ADMINISTRATIVE AMENDMENT

A TENANT IMPROVEMENT AT 360 EUBANK BLVD. NE
LAUNDROMAT FOR TONY BYRNE

SITE PLAN

A-1

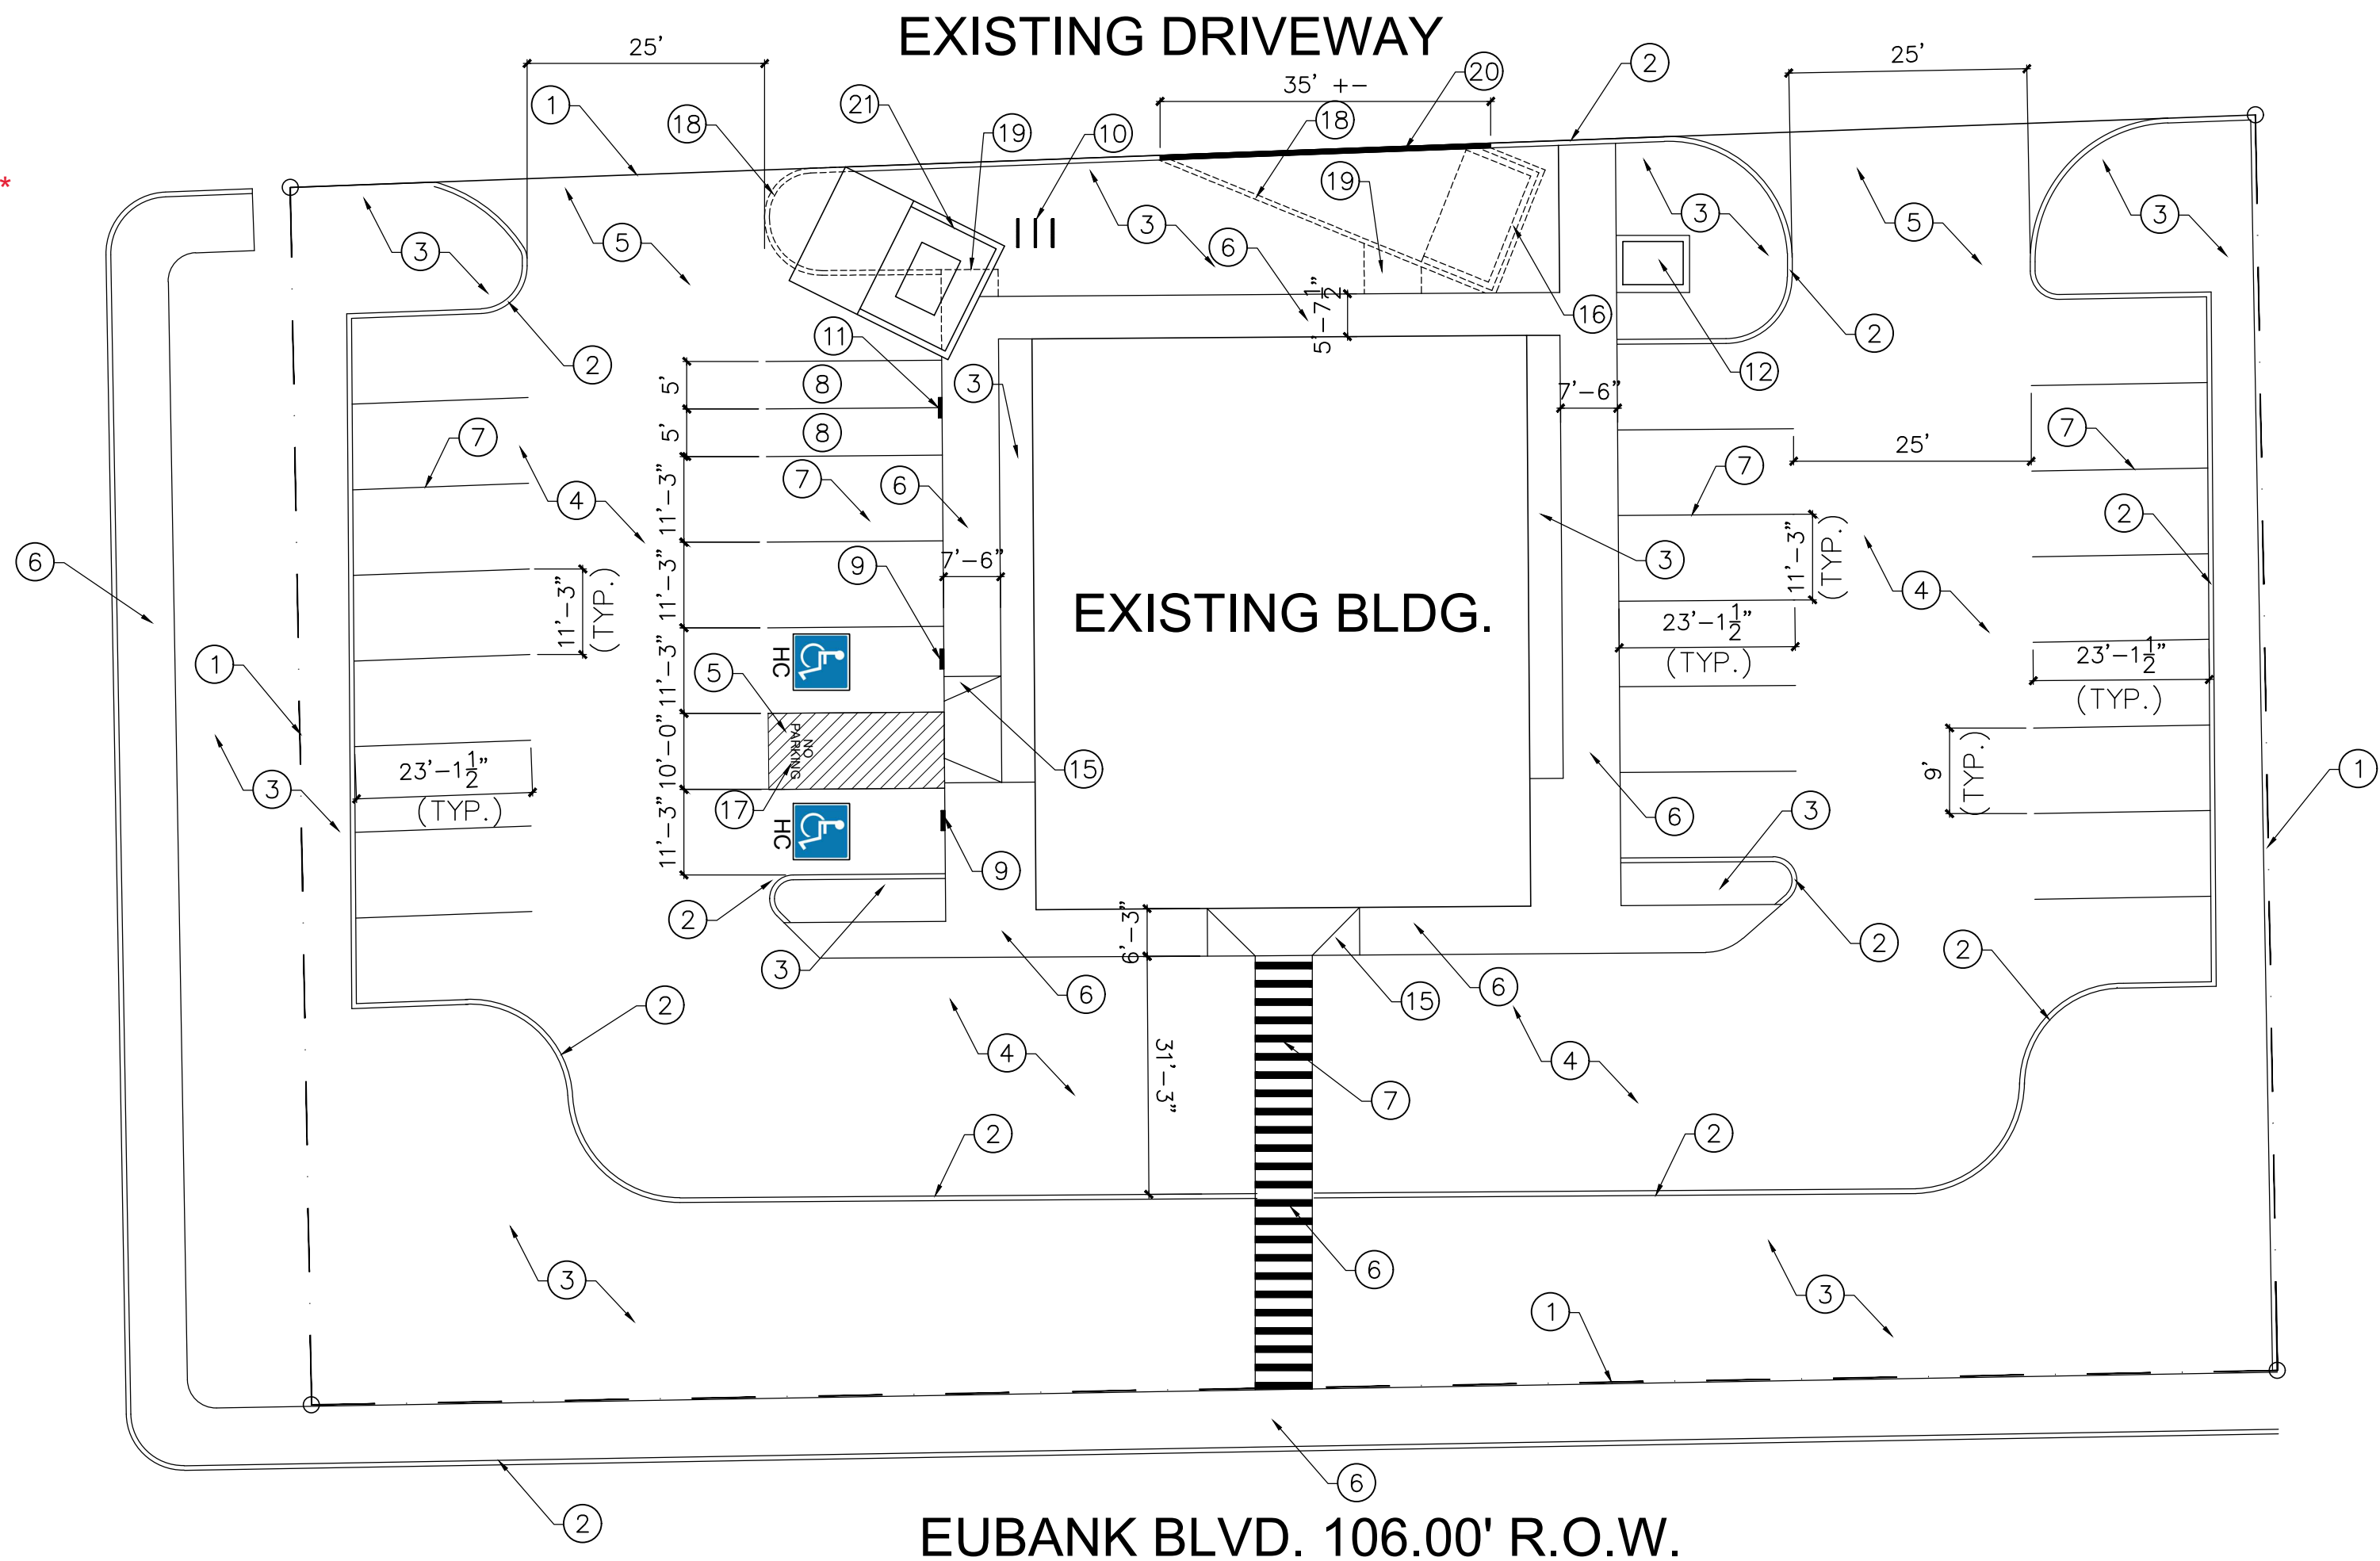
Approved for access by the Solid Waste Department
Herman Gallegos 06-16-21 *Herman Gallegos*
**Condition is all the existing curb in front and around
the trash enclosure has to be removed or approval is void.**
